SUBJECT: HWG COMMENTS ON CITY OF MARINA DRAFT GROUNDWATER SUSTAINABILITY PLAN FOR THE MARINA GSA AREA OF THE 180/400 FOOT AQUIFER SUBBASIN DATED OCTOBER 2019

This letter provides the comments of the Hydrogeologic Working Group (HWG) on the City of Marina's Draft Groundwater Sustainability Plan (GSP) for the proposed City of Marina (Marina) Groundwater Sustainability Agency (GSA) Plan Area of the 180/400 Foot Aquifer Subbasin. Marina developed this Draft GSP for a very small area (400 acres) already covered by the Salinas Valley Basin (SVB) GSA Groundwater Sustainability Plan, thereby creating many current and potential future conflicts for meeting the requirements of the Sustainable Groundwater Management Act (SGMA). The Marina GSP develops a monitoring network with Representative Monitoring Sites (RMS) and sets sustainable management criteria (SMC) for locations largely outside of its Plan Area. Regardless of the conflicts it creates, the City of Marina Draft GSP is based on a faulty Basin Setting, unjustified sustainable management criteria, and makes no attempt to address the only viable aquifer within its boundaries (the Deep Aquifer). This letter provides both an Executive Su

Figure 1 Locations of MPWSP Boreholes Relative to GSP Potential Aquitard Gap Areas

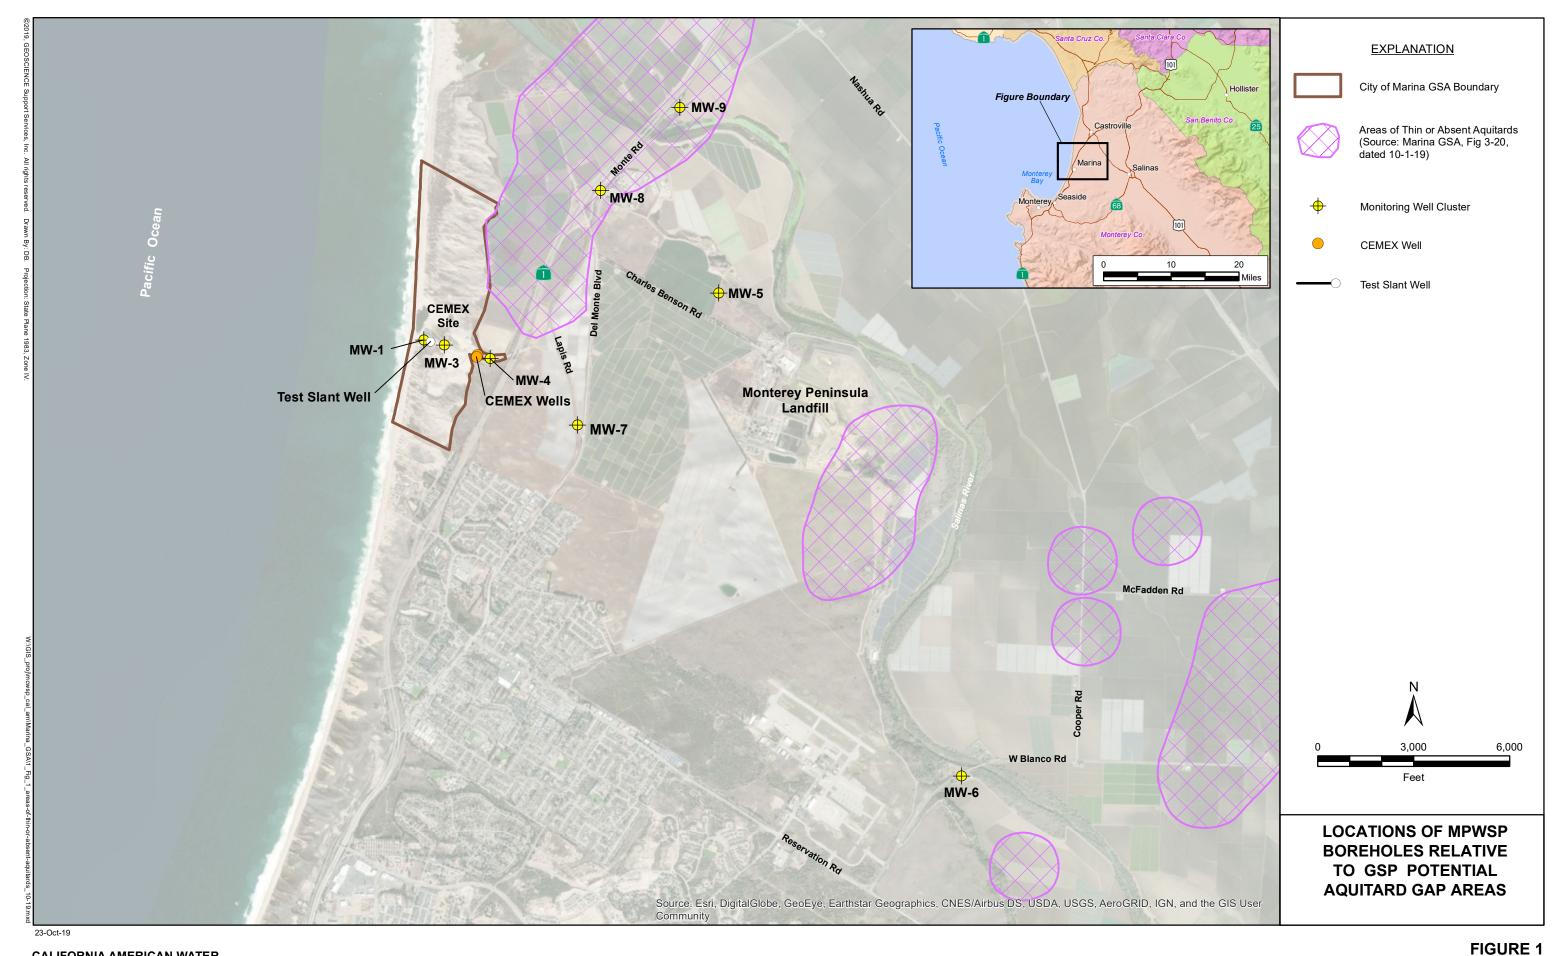
27. The GSP describes the chloride islands found in a study by MCWRA that are located approximately 3.5 to 4.5 miles inland of the MGSA, presents a potential aquitard gap map in Figure 3-20, and generally implies this issue is relevant in the MGSA Plan Area. (Section 3.1.12, page 3-20). The chloride island issue is discussed in other places in the GSP as well (e.g., Section 3.2.3.2, page 3-37).

HWG 44 **HWG Comment:** This issue of possible aquitard gaps and chloride islands was documented at locations far inland and not relevant to the Marina GSP. In addition, detailed work by MCWRA was able assign these chloride islands to being caused by poorly constructed wells. The cited study by MCWRA did not have MPWSP monitoring well boring logs available to incorporate in their study. The locations of the MPWSP borings relative to the purported aquitard gaps (GSP Figure 3-20) is displayed in the attached **Figure 1**. MPWSP MW-8 has a major clay zone present from approximately 225 to 295 feet bgs and MW-9 has a major clay zone present from approximately 225 to 350 feet bgs (aquitard intervals in other boreholes include: MW-1: 210-275; MW-3: 215-285; MW-4: 260-300; MW-5: 305-395 (higher ground elevation); and MW-7: 225-270).
